Form 3160-5  
(June 2019)UNITED STATES  
DEPARTMENT OF THE INTERIOR  
BUREAU OF LAND MANAGEMENTFORM APPROVED  
OMB No. 1004-0137  
Expires: October 31, 2021**SUNDRY NOTICES AND REPORTS ON WELLS**  
**Do not use this form for proposals to drill or to re-enter an abandoned well. Use Form 3160-3 (APD) for such proposals.**5. Lease Serial No. **NMNM77063**

8. Well Name and No. **FRODERICK 33 FED/510H**9. API Well No. **30-025-52157**10. Field and Pool or Exploratory Area  
**WC-025 G-08 S243217P; UPPER WOLFCAMP**11. Country or Parish, State  
**LEA/NM****12. CHECK THE APPROPRIATE BOX(ES) TO INDICATE NATURE OF NOTICE, REPORT OR OTHER DATA**

Froderick 33 Fed Com 745H (FKA 510H) API #: 30-025-52157

EOG respectfully requests an amendment to our approved APD for this well to reflect the following changes:

Form C-102  
Revised August 1, 2011  
Submit one copy to appropriate  
District Office  
☐ AMENDED REPORT

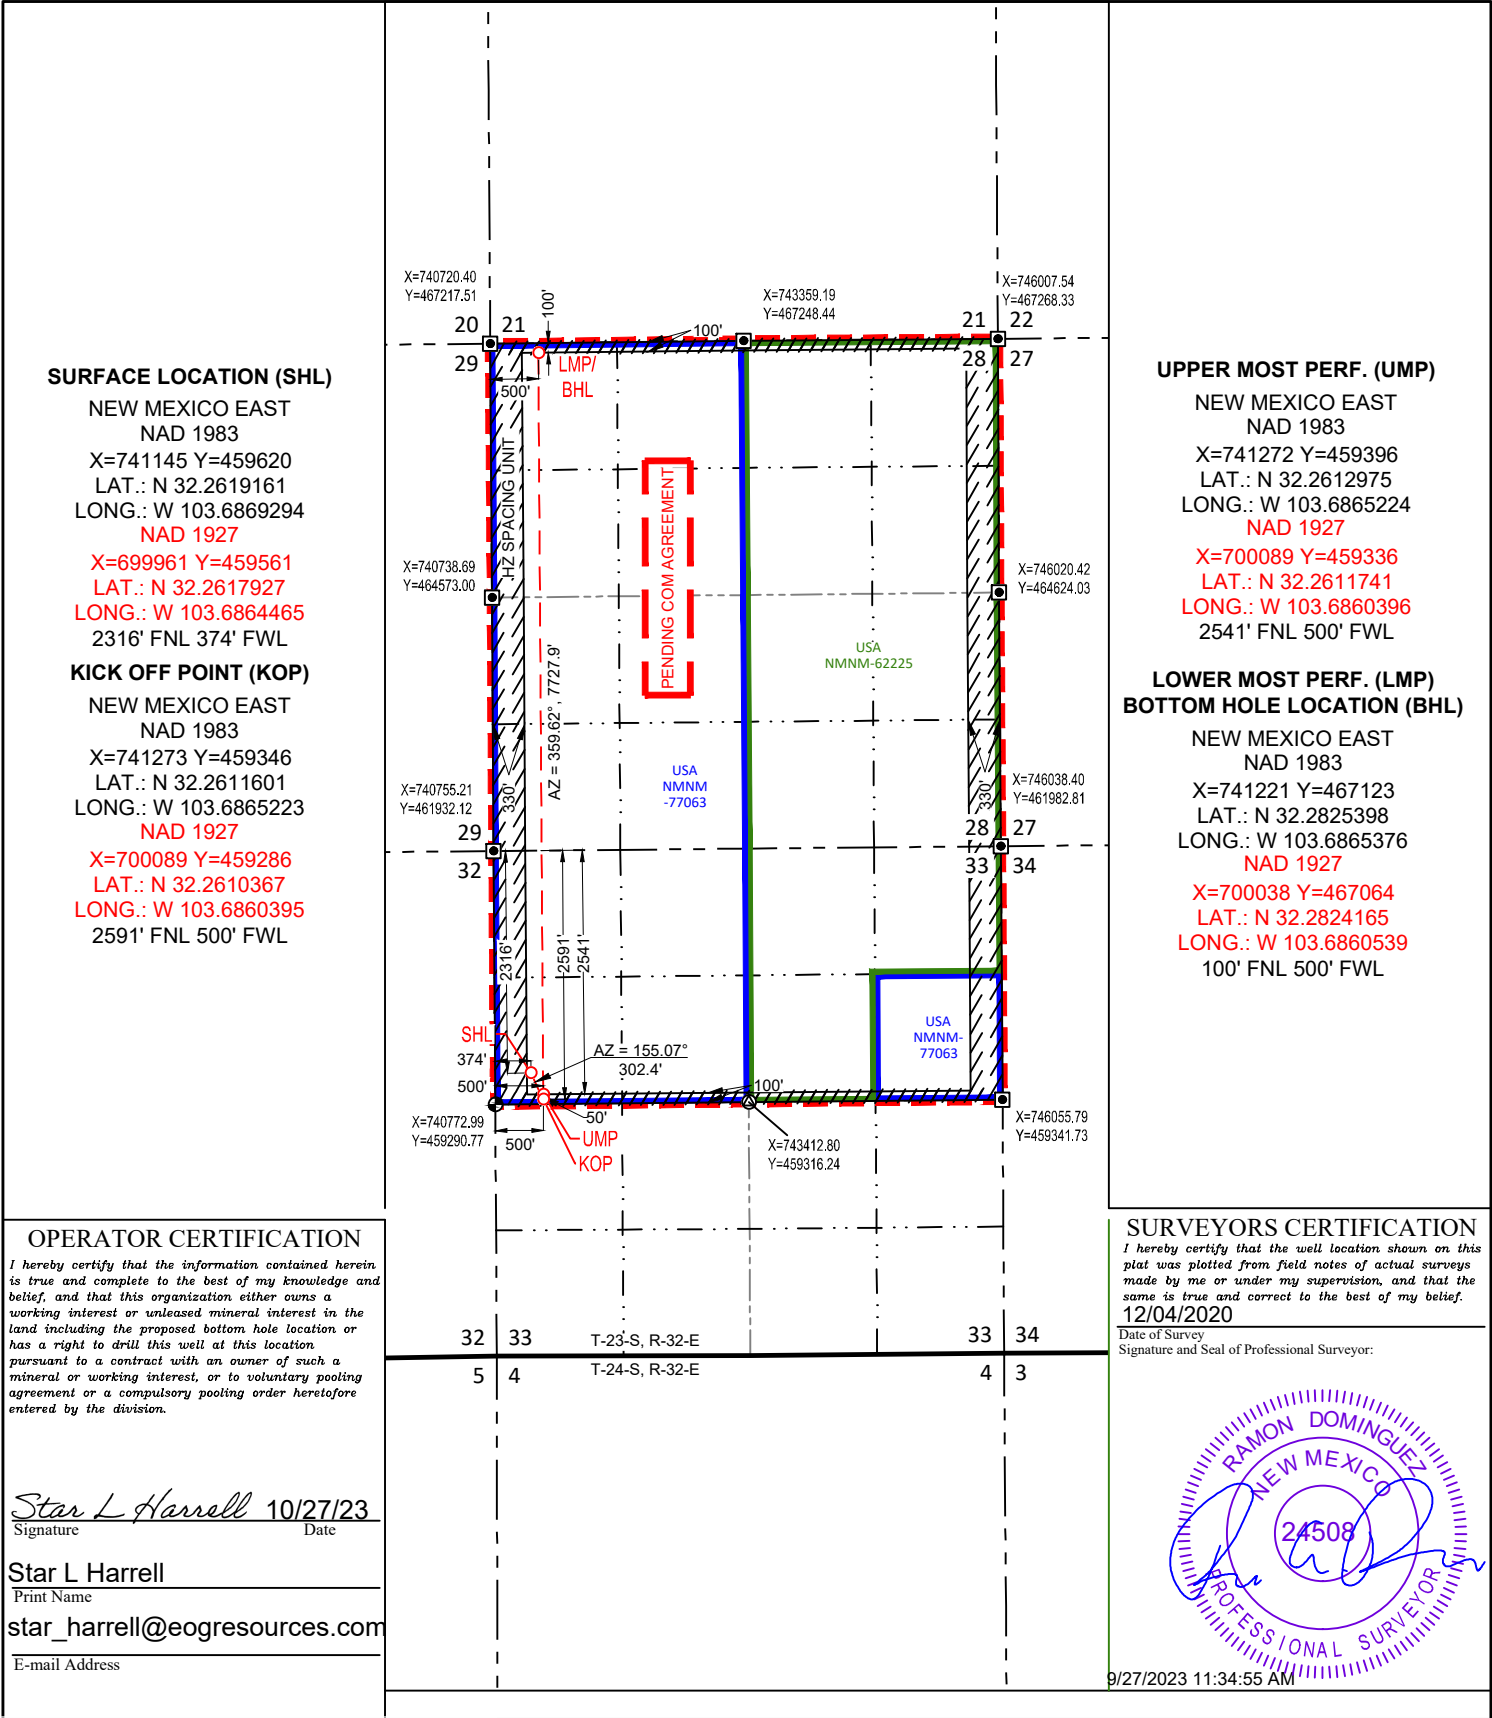
Change BHL from T-23-S, R-32-E, Sec 28, 100' FNL, 792' FWL, Lea Co., NM, to T-23-S, R-32-E, Sec 28, 100' FNL, 500' FWL, Lea Co., N.M.

Update the Pool as reflected in the C-102.

UL or lot no.	Section	Township	Range	Lot Idn	Feet from the	North/South line	Feet from the	East/West line	County
D	28	23-S	32-E	-	100'	NORTH	500'	WEST	LEA

Dedicated Acres 960.00	Joint or Infill	Consolidated Code	Order No. PENDING COM AGREEMENT
---------------------------	-----------------	-------------------	------------------------------------
